APPLICATION NO.	FILING DATE	FIRST NAMED INVENTOR	ATTORNEY DOCKET NO.	CONFIRMATION NO.
09/878,325	06/12/2001	Tsuyoshi Kitahara	Q64826	2121

Office Action Summary

DETAILED ACTION

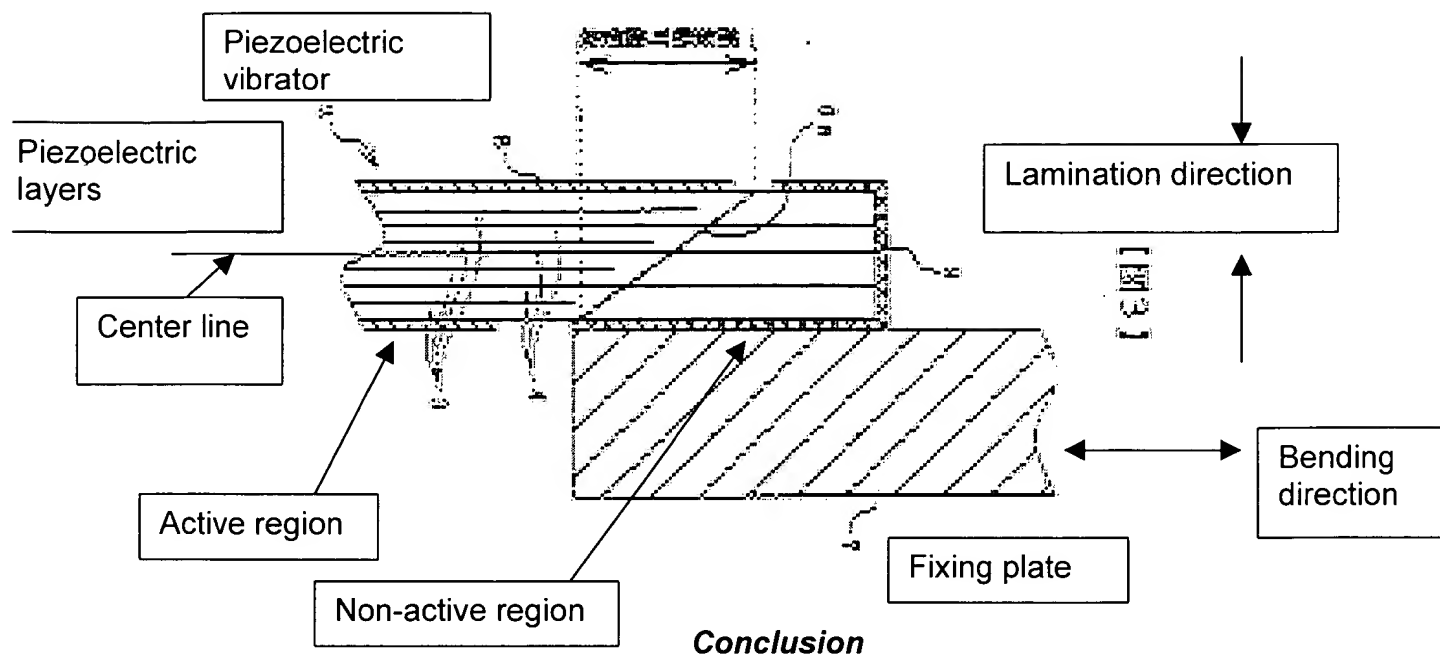
- Common internal electrode layers (Fig.3: element 4) and segment internal electrode layers arranged alternately (Fig.3: element 3)
- Piezoelectric layers, each interposed between adjacent pair of the common and segment internal electrode layers (Fig.3)

- External electrodes formed on an exterior of the piezoelectric vibrator and electrically connected respectively to the common internal electrode layers and the segment internal electrode layers (Fig.3: element 9)

- A fixing member to which a surface of the piezoelectric vibrator is fixed (Fig.3: element 7)
- The piezoelectric vibrator is displaceable in a direction perpendicular to a lamination direction in which the internal electrode layers and piezoelectric layer are laminated (Fig.3)

- A length of at least one of the internal electrode layer, located away from the surface fixed to the fixing member is shorter than other internal electrode layers (Fig.3).

- Piezoelectric layers are non-uniform in thickness (Fig.3)
- Internal electrode layers are non-uniformed in the thickness (Fig.3)

With respect to claim 6, Kitahara discloses at least one of the piezoelectric layer located away from the surface fixed to the fixing member is thicker than other piezoelectric layer (Fig.3).

With respect to claim 11, Kitahara discloses at least one of the internal electrode layers located away from a center line in the lamination direction is thicker than other internal electrodes (Fig.3)

With respect to claim 12, Kitahara discloses that an internal electrode layer is located farther from the surface fixed to the fixing member in the lamination direction, the internal electrode layer is thicker (Fig.3)
